From: Hixson, Kevin <KHixson@blcompanies.com>
Sent: Tuesday, July 7, 2020 9:28 AM
To: Charles Lis, Heather
Cc: Roles, Robert; Fournier, Loni; Klose, Alexander; Violette, Wayne; Savage-Dunham, Mary
Subject: RE: 100 Industrial Park NOI revised plan comments
Attachments: LL190151701-LL-4 24x36 (002).pdf

From: Charles Lis, Heather <LisH@hingham-ma.gov>
Sent: Friday, June 5, 2020 1:21 PM
To: Hixson, Kevin <KHixson@blcompanies.com>
Cc: Roles, Robert <rroles@Blcompanies.com>; Fournier, Loni <fournierl@hingham-ma.gov>
Subject: 100 Industrial Park NOI revised plan comments

PROPOSED DEVELOPMENT
100 INDUSTRIAL PARK ROAD
HINGHAM, MASSACHUSETTS

Title
EXISTING TREE PLAN

Sheet No.
LL-4

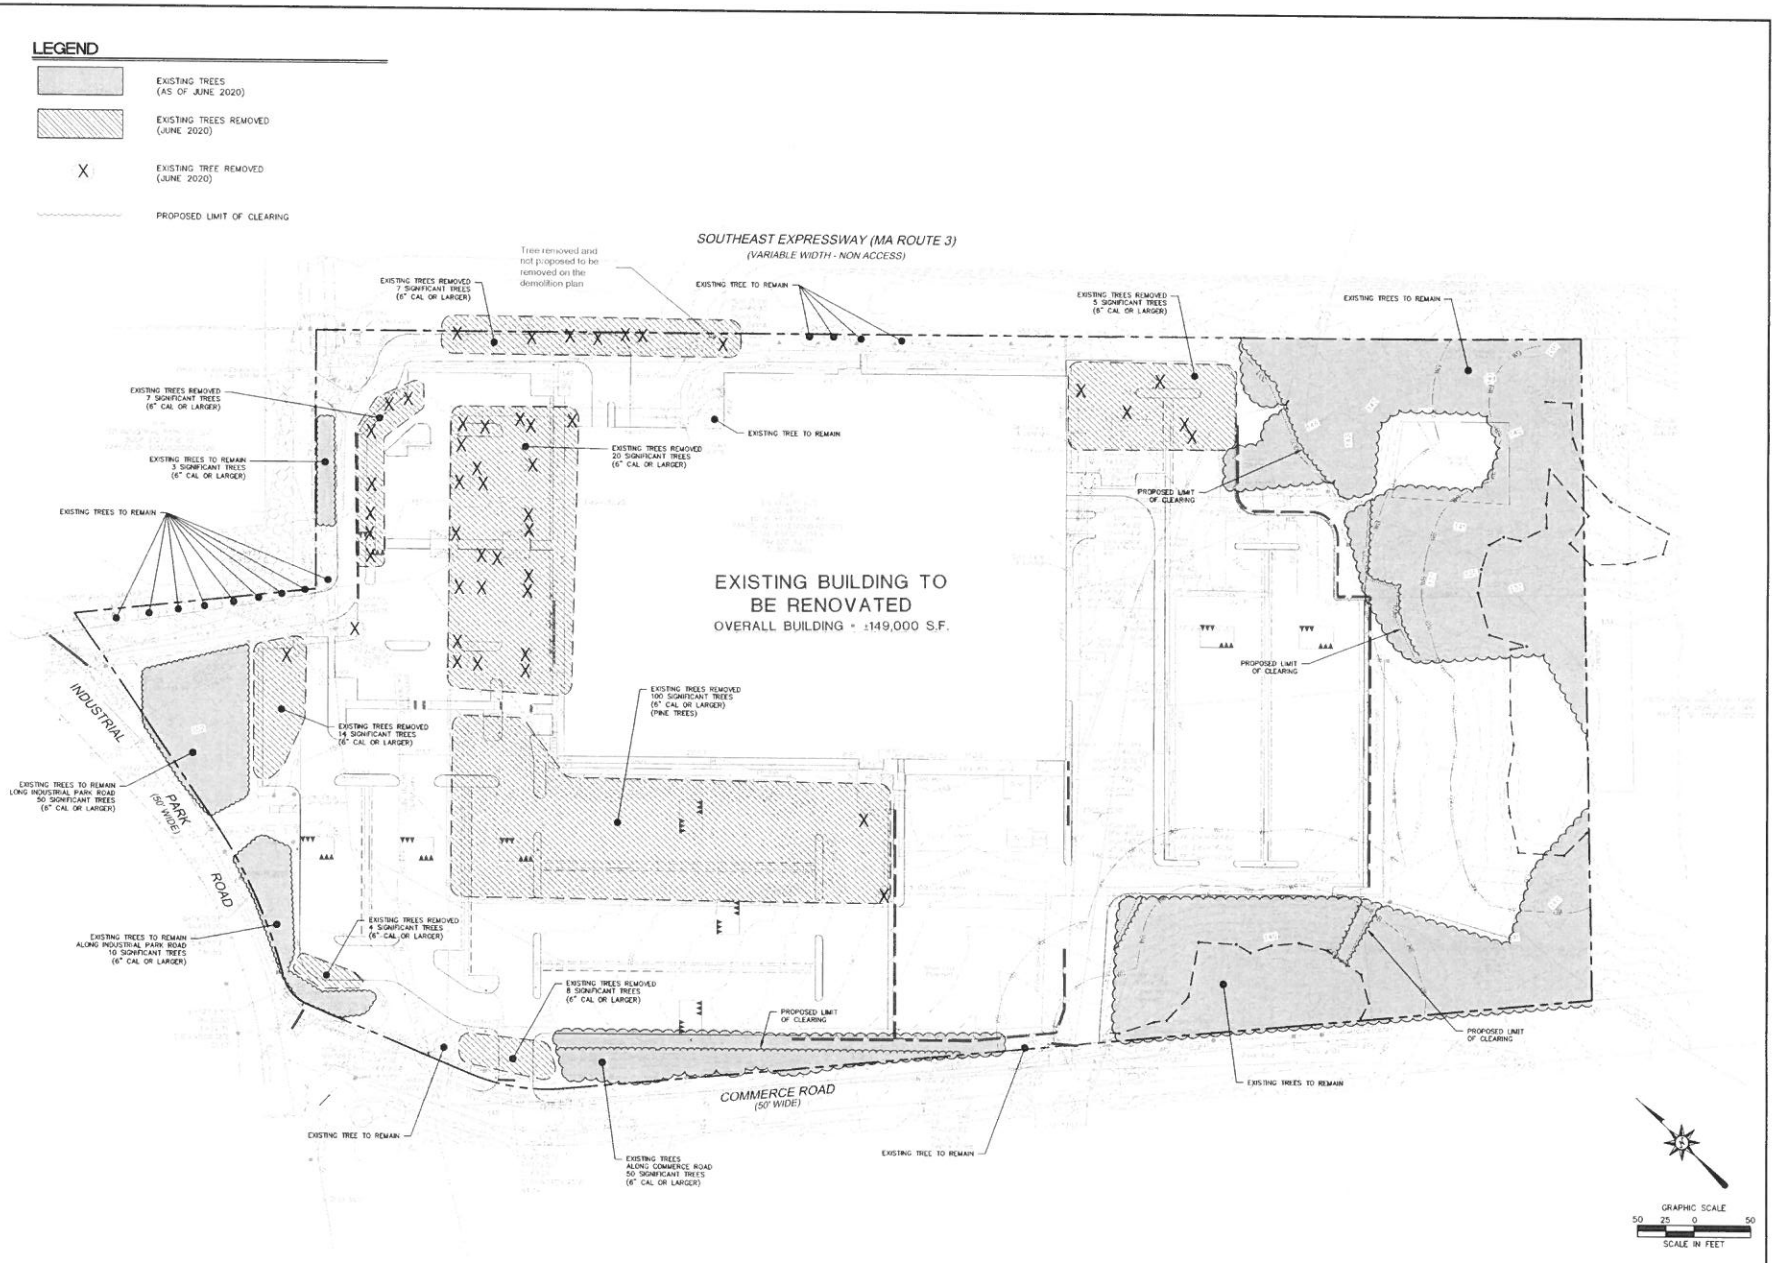
Good morning. Please find the attached PDF tree survey plan based on our June 30th site visit that was made after the tree removal for the site. We shaded the gray area with a tree cloud limit line in black to denote existing tree line to remain in proposed development condition. We also added a red cloud to denote the proposed tree clearing limit in proposed condition so both could be viewed at the same time. Trees with an X are existing trees that were removed in a landscaped grass/mulch area. One tree that was not proposed to be removed in the demolition plan was confirmed removed west of the northwest corner of the main building. We have the details on species and exact size for each however for this plan we have kept it at a high level summary.

We did confirm that no trees were removed within the 50' or 100' buffers. We noted one tree (36" Oak) was removed on the west side of the northwest corner of the main building that was not supposed to be removed per the Demolition Plan. We will note that in our tree survey plan. See image of the location in the same link above.
